**TITLE: PNEUMATIC - DISTRIBUTION - INSTALL NEW BLEED GIMBAL
STANDARD REFERENCE - LHS**

MODIFICATION No.:
114810L91112

This Service Bulletin consists in replacing a bleed gimbal Standard (STD) on Left Hand (LH) wing.

Removal of the Bleed Gimbal Standard
Reference for the LH Wing to Pylon Interface

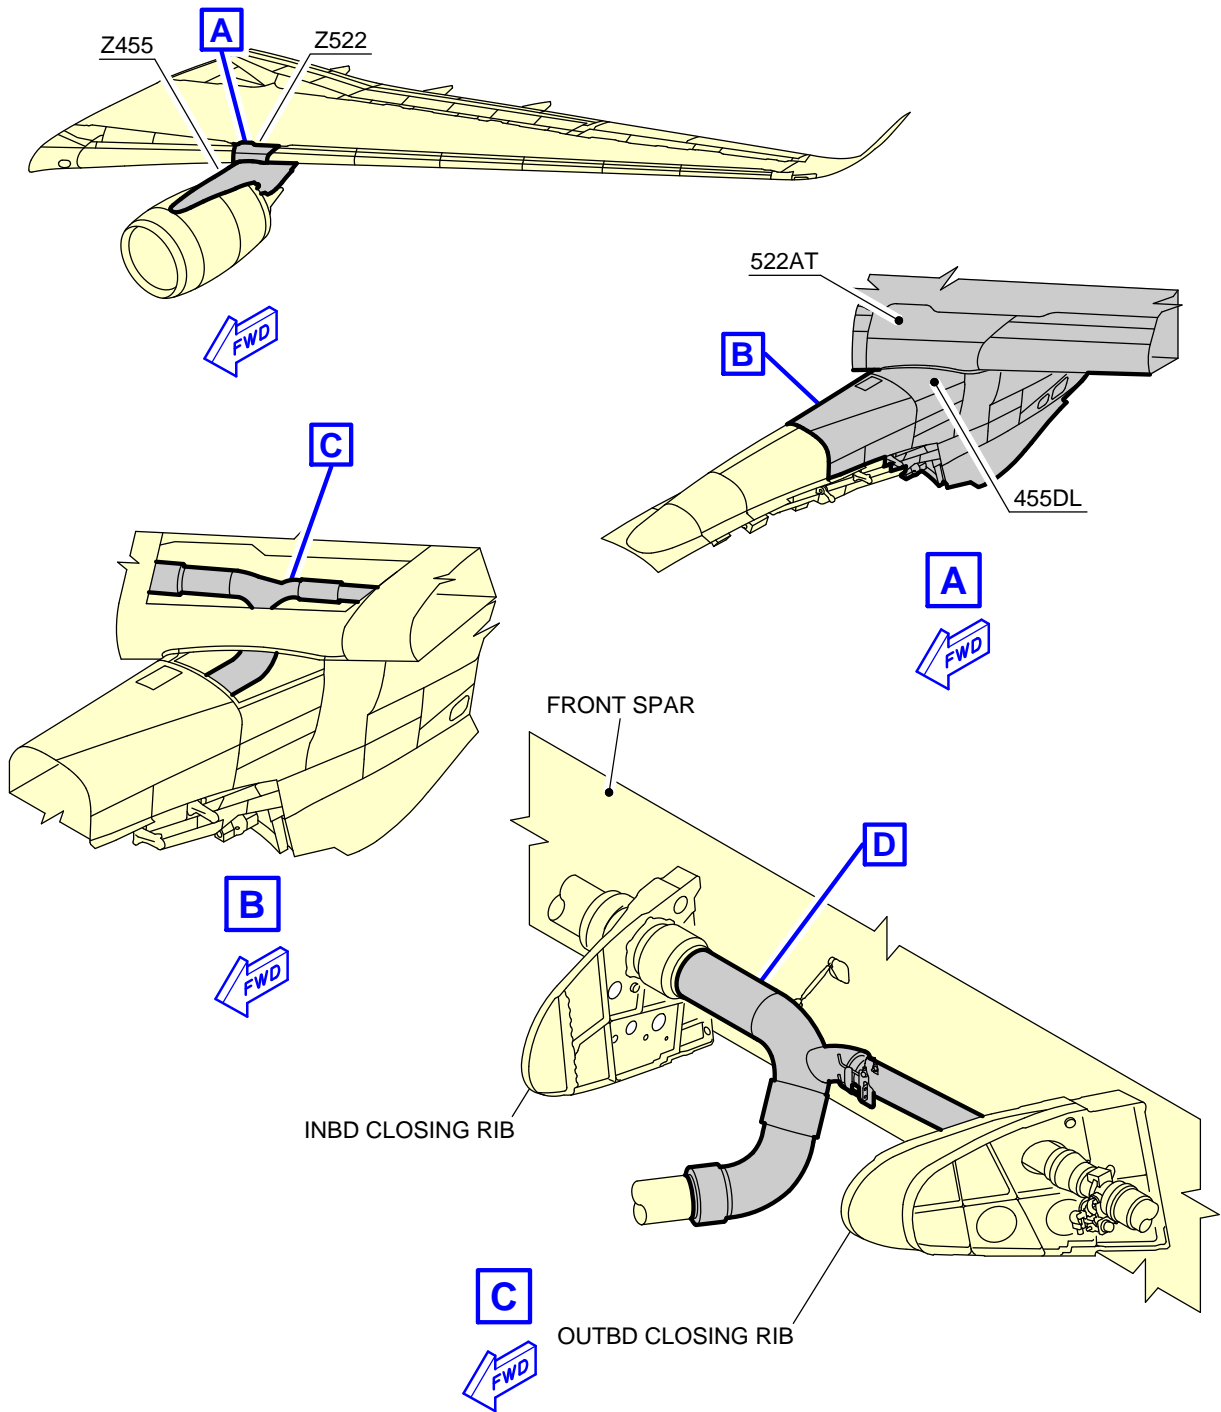
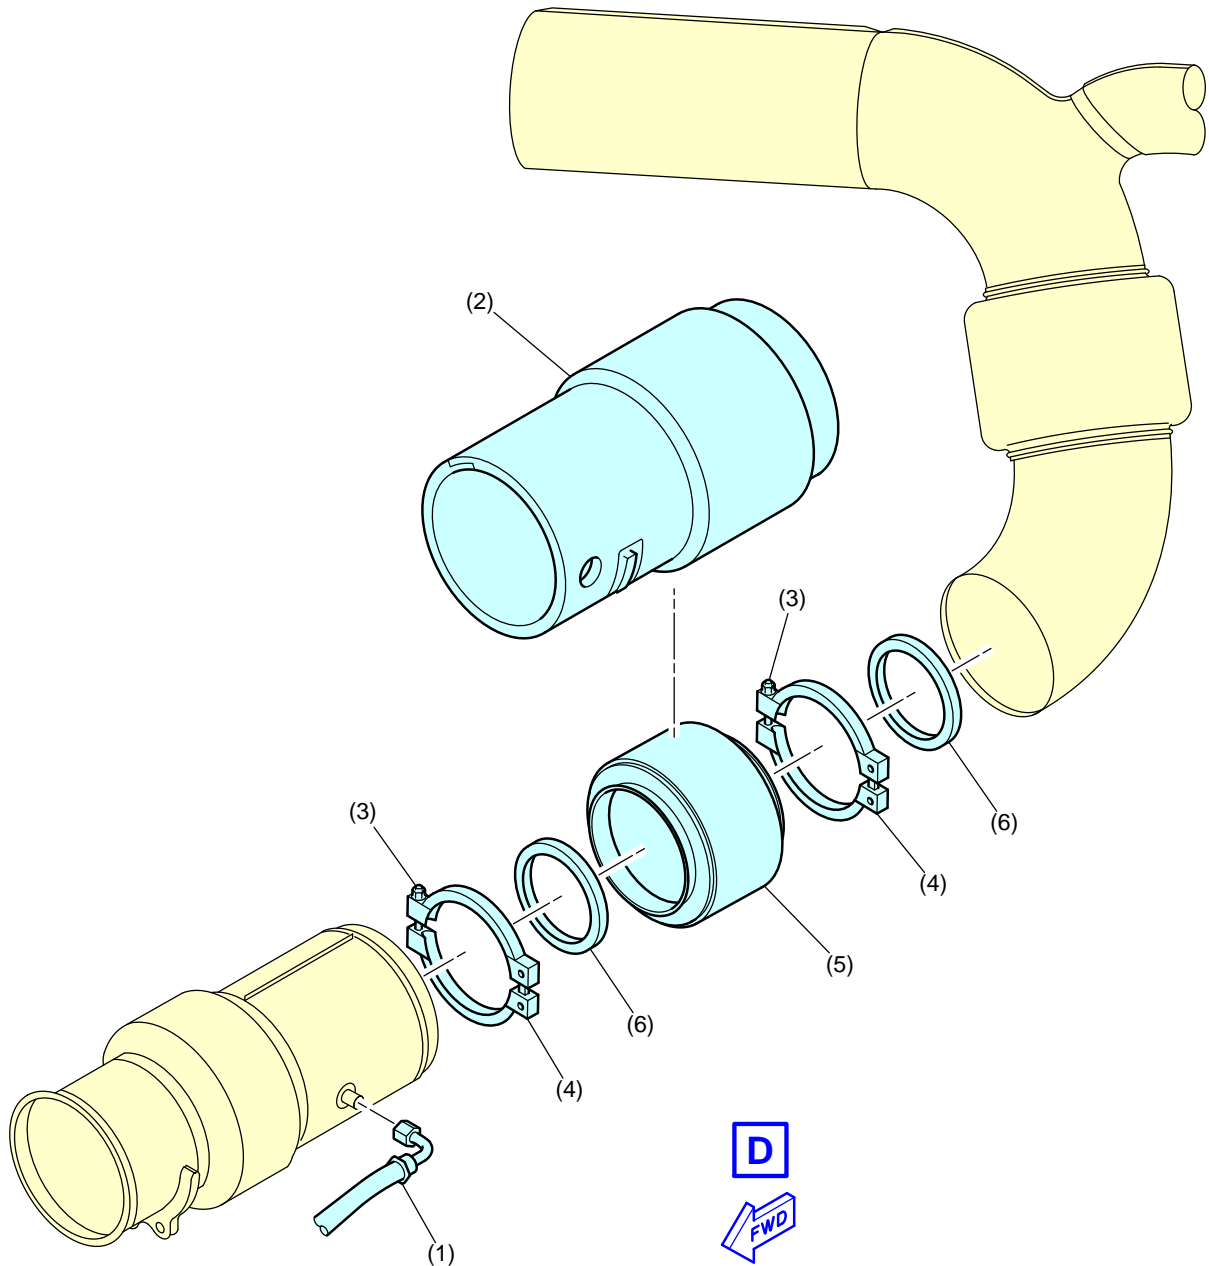
Refer to Ref. Fig. Removal of the Bleed Gimbal Standard Reference for the LH Wing to Pylon Interface

- 1 Disconnect the hose assembly, Item (1), to remove the muff, Item (2).
- 2 Release the velcro tapes of the muffs, Item (2), to open this.
- 3 Remove and retain the muff, Item (2):

2	SELF LOCKING NUT	Item (3)	Retain
2	CLAMP	Item (4)	Retain
- 5 Remove the gimbal, Item (5):

1	JOINT-GIMBAL	ABS0736E9696S	Item (5)	Discard
---	--------------	---------------	----------	---------
- 6 Remove the applicable E-seal, Item (6):

Figure ICN-A350-A-36XXP023-A-FAPE3-05BQ5-A-001-01 SHEET 1/3

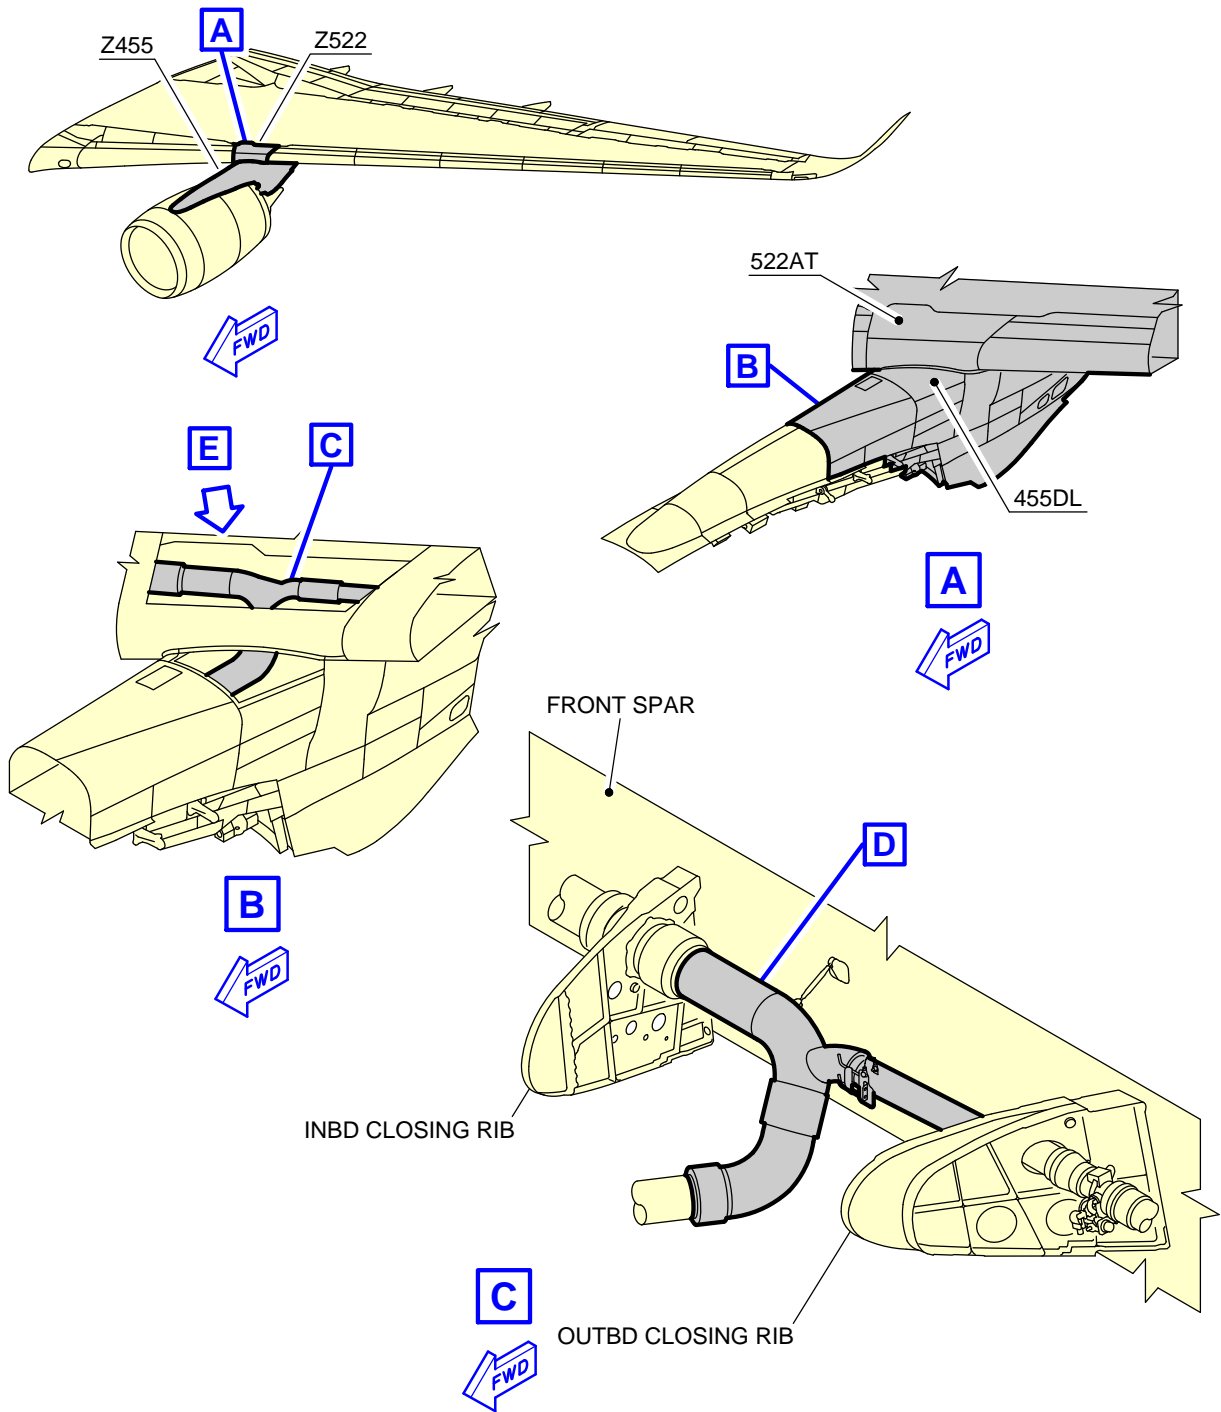
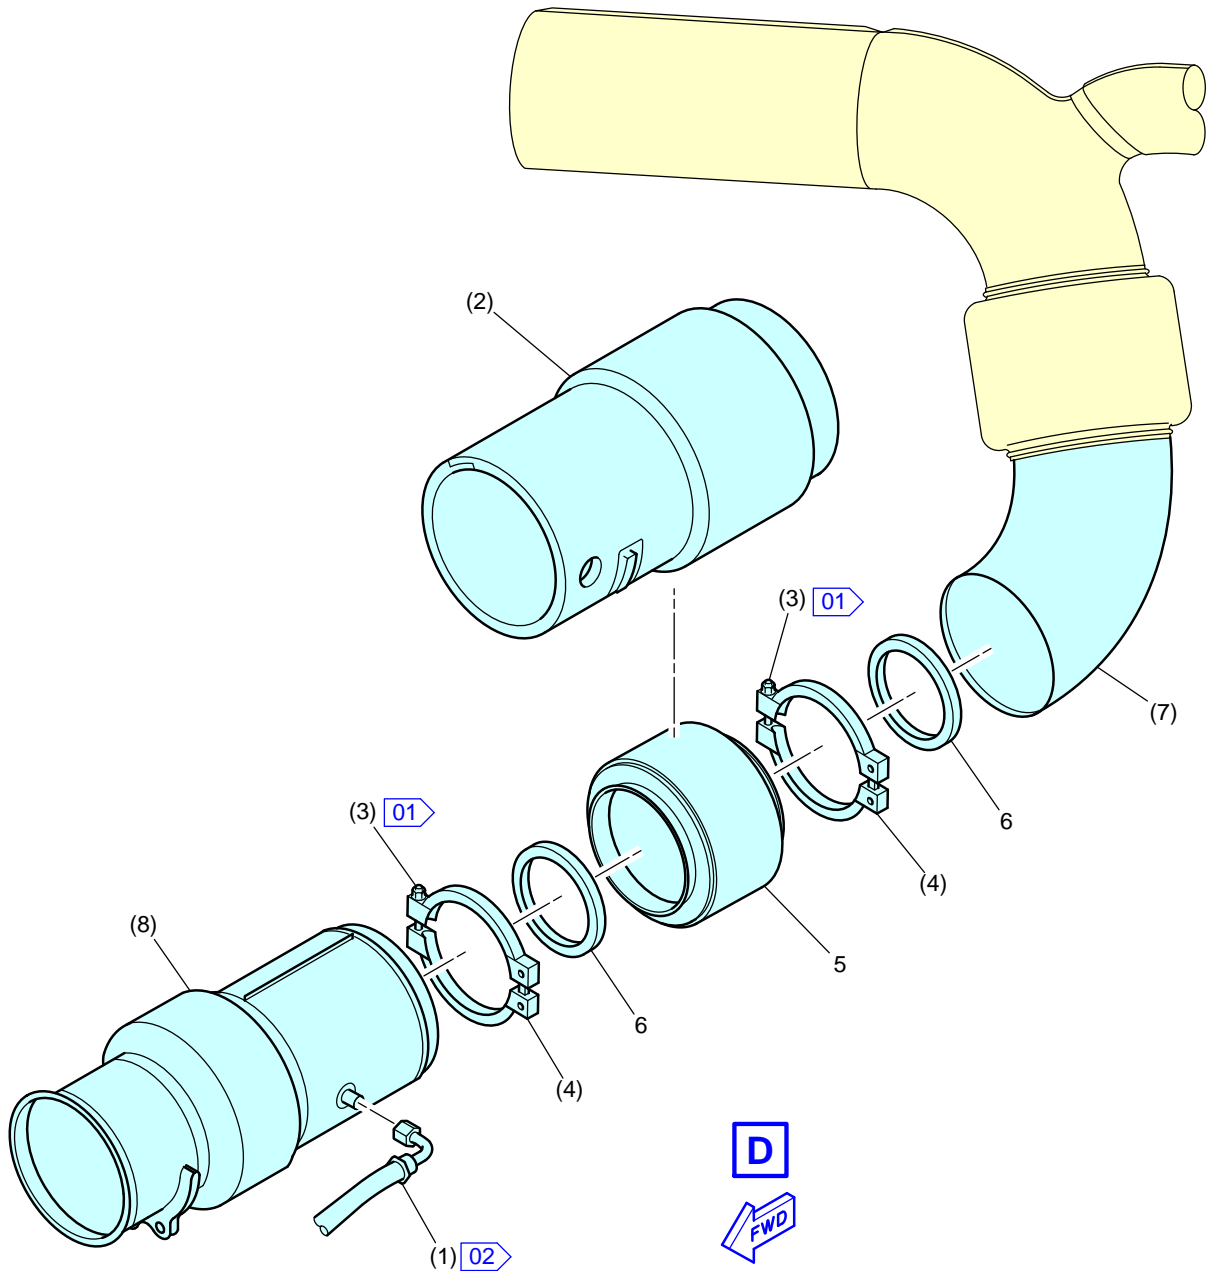
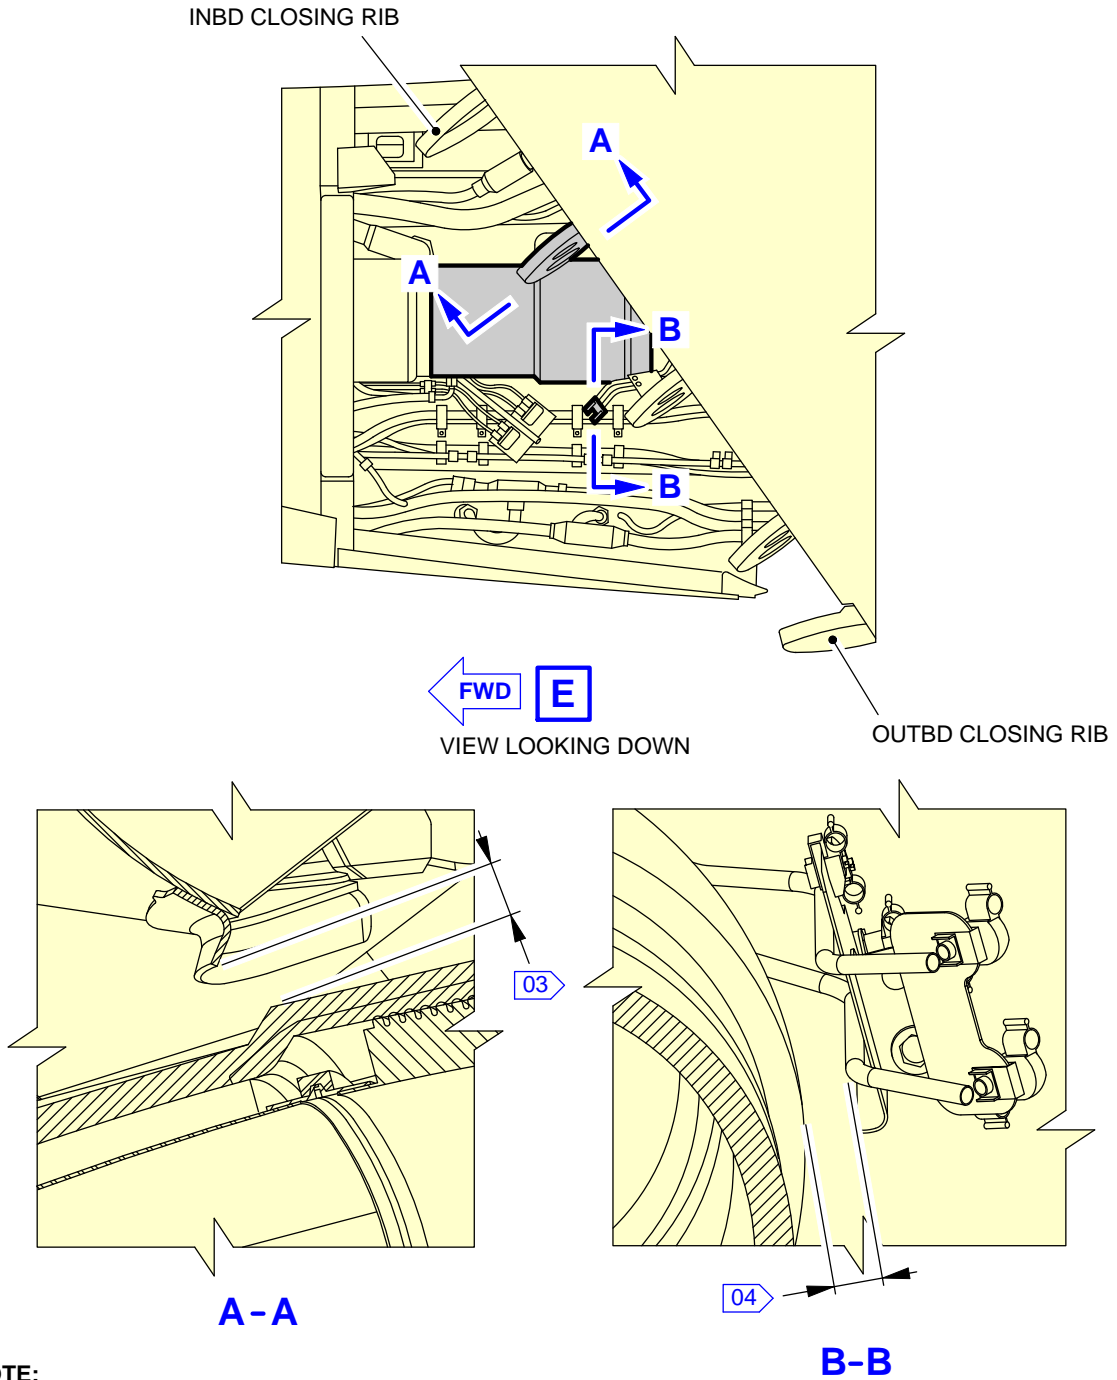
- (b) Install the new bleed gimbal:
Refer to Ref. Fig. Installation of the Bleed Gimbal Standard Reference for the LH Wing to Pylon Interface
- 1 Remove the blanking plug from each disconnected duct end.

- 2 Put the gimbal, Item 5, in position between the pipe junction, Item (7), and the pipe junction, Item (8):
- | | | | | |

| | <u>4</u> | Engage the gimbal, Item 5, with the pipe junction, Item (7), and put the clamp, Item (4), on the E-seal, Item 6: | | |

8 Torque the self locking nuts, Item (3), to between 3.39 and 3.95 Nm (30.004 and 34.960 lbf.in.).

NOTE: Be careful to make sure to respect the minimum distance from the elements of structure at 20 mm (0.787 in.).

NOTE: Be careful to make sure to respect the minimum distance from environment at 5 mm (0.197 in.).

- 01** TORQUE THE SELF LOCKING NUTS, ITEM (3), TO BETWEEN 3.39 AND 3.95 Nm (30.004 AND 34.960 lbf.in).
- 02** TORQUE THE HOSE ASSEMBLY CONNECTION, ITEM (1), TO BETWEEN 24.30 AND 31.60 Nm (215.073 AND 279.684 lbf.in).

- 03 MINIMUM DISTANCE FROM THE ELEMENTS: 20 mm (0.787 in).
- 04 MINIMUM DISTANCE FROM THE WING ENVIRONMENT: 5 mm (0.197 in).
